18-080DPR/SPR BRIDGE PARK, BUILDING F1

Planning and Zoning Commission

Development Plan (DPR) and Site Plan Review (SPR) for a new building containing a hotel and restaurant space and a private street.

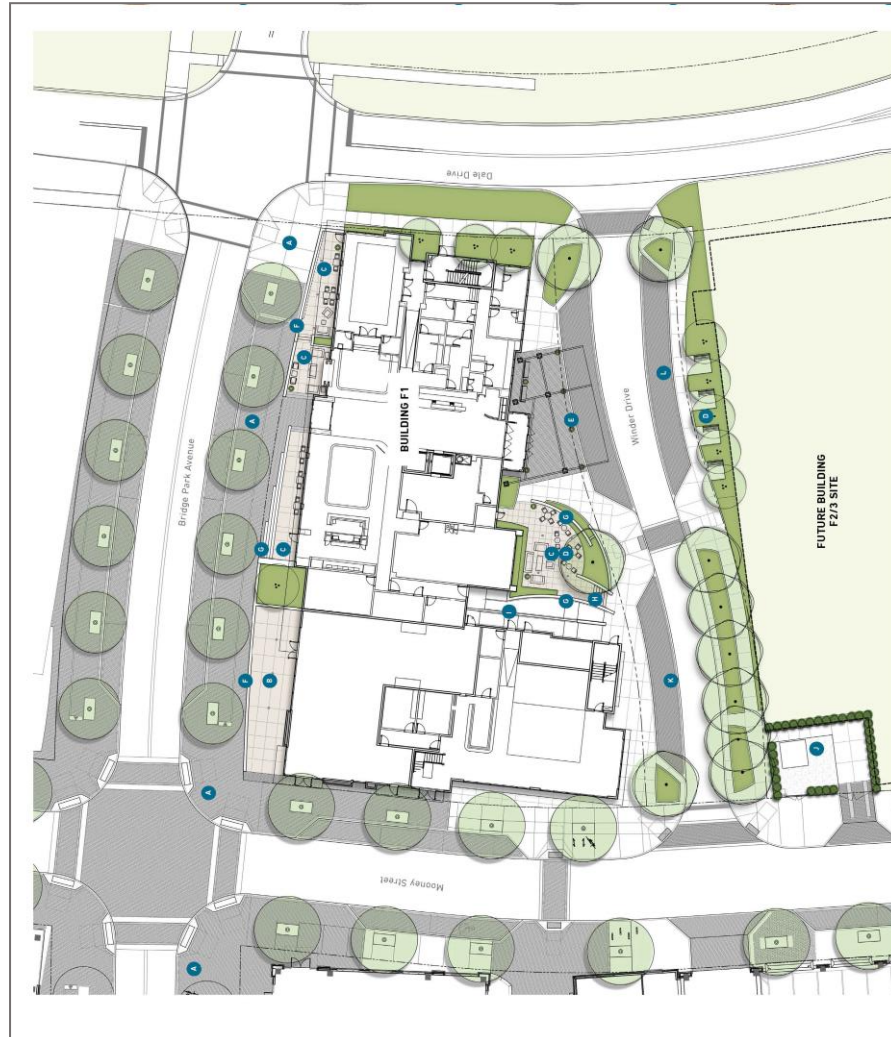
Based on the square footage of the commercial uses proposed, a total of 0.04-acre (1,910 square feet) of publicly accessible open space is required with this Site Plan. A total of 0.03-acre (1,203 square feet) of open space are provided as a Pocket Park on the south side of the building, north of Winder Drive (Private). The Pocket Park is defined as part of Building F1, steps and retaining walls and is programmed with a variety of seating areas. Based on the proximity of the proposed Pocket Park to the hotel and the degree of separation from the public right-of-way and other existing open spaces, the primary users of this space will be hotel guests. The applicant has not provided the height of the proposed retaining walls, which appear to potentially exceed the permitted height of six feet. The applicant will have to clarify the proposed retaining wall height prior to review by the Commission as a waiver be required.

- Open Space Size/Dimensions: Waiver to permit less publicly accessible open space than is required based on the proposed mix of uses
- Open Space Accessibility/Ownership: Waivers to permit a Pocket Park with no portion of the perimeter adjacent to the street right-of-way and to permit an open space on a privately owned parcel with no access to the space provided along a public right-of-way.
- Open Space Orientation: Waiver to permit a Pocket Park oriented toward the rear property line as opposed to the front or corner side property lines.

The required reviewing body shall make a determination of the suitability of the proposed Pocket Park to meet the open space requirement. The applicant has designed the access drive in a manner that it similar to the access drive for the AC Hotel and while that drive is also private it is designed and functions largely like one of the public streets within Bridge Park. Smaller open space areas are also proposed along the Bridge Park frontage to be accessible to the public, however these areas are smaller than the open space types as outlined in the Code.

- 1) That the applicant evaluate opportunities for provision of required publicly accessible open space;
- 2) That the applicant provide a public access easement to and over the proposed Pocket Park;
- 3) That an on-street van accessible parking space be provided based on the provision of 3 new parking spaces;
- 4) That bicycle parking spaces be provided as required by Code;
- 5) That exterior lighting specifications for all proposed fixtures be submitted with building permits;
- 6) That exterior lighting be provided in the area of the Pocket Park to meet the minimum footcandle requirements of Code;

- 7) That details and specifications for the proposed vehicular canopy be submitted with building permits; and
- 8) That the applicant verify the proposed height of the retaining walls surrounding the open space along Winder Drive and request any necessary approvals should they exceed Code-permitted height.
